MONTGOMERY COUNTY PLANNING DEPARTMENT

MEMORANDUM

Briefing on Staff Action for a New Application:

Final Forest Conservation Plan SC2008014

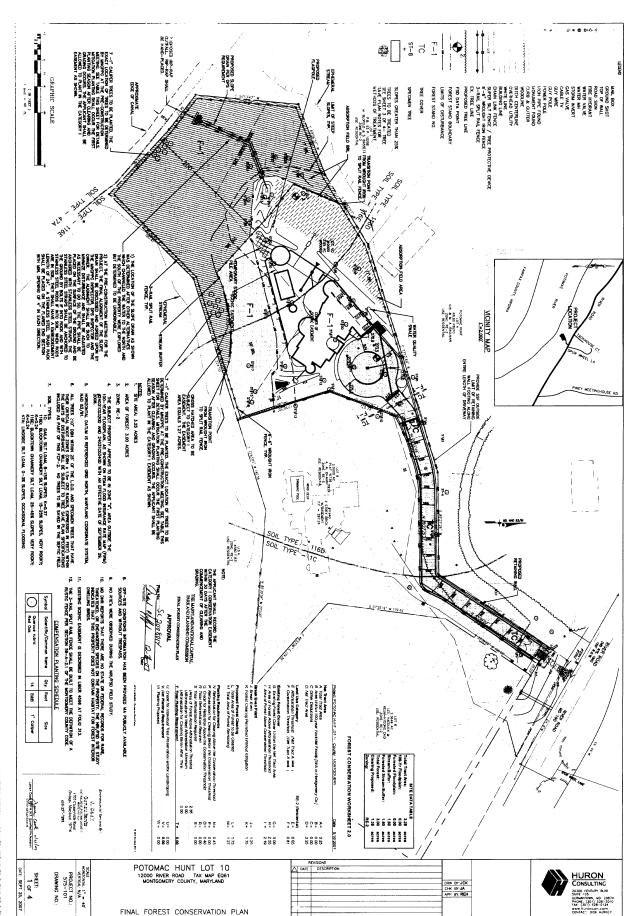
The previously submitted Forest Conservation Plan (SC2007003) showed an ornamental fence five feet from the property line and within the proposed forest conservation easement. The plan also showed an ornamental fence within 20 feet from the common property line with the United States Government. Since the staff's denial of forest conservation SC2007003, the County Council enacted Zoning Text Amendment 07-04 which prohibits anything but rustic fences within 200 feet of a National Park. Forest Conservation Plan SC2008014 complies with this requirement. The Applicant will construct a three rail split fence along the perimeter of the property for all areas within 200 feet of the National Park Service property. The Applicant's plan shows an ornamental fence bisecting the property and no closer than 200 feet to the national park, and not within any portion of the property subject to the Category I conservation easement. At the property lines the split rail fence will transition into an ornamental fence and continue to comply with zoning text amendment.

The Application locates the ornamental fence along the border of the Category I easement area. In order to protect his children from exposure to certain nut trees to which they are allergic, the Applicant proposes to remove four nut trees from areas that are outside of the limits of disturbance, and that are located either inside or near the ornamental fence, which will keep the Applicant's children from being exposed to nut trees. Three of these trees are outside the conservation easement. The largest of the three trees is 5 inches in diameter. The fourth tee, a 5-inch dbh hickory tree located at the edge of the conservation easement, where the tree canopy might grow over the ornamental fence, is located within the conservation area. The Applicant will compensate for the loss of all four of the removed trees with planting 14 one-inch caliper native trees within the conservation easement area. The trees will be planted in the area immediately adjacent to the 5-inch hickory tree and near the common property line with the United States Government.

Finally, forest conservation plan SC2008014 shows the required stormwater management pipe and outfall on the western side of the property. This discharge is necessary to safely convey stormwater down the steep slope. Forest conservation plan SC2007003 did not include this pipe and outfall. The alignment of the slope drain will be field adjusted to minimize disturbance. The pipe will be placed on the ground and be anchored to the ground with stainless steel bolts or rods to minimize land disturbance.
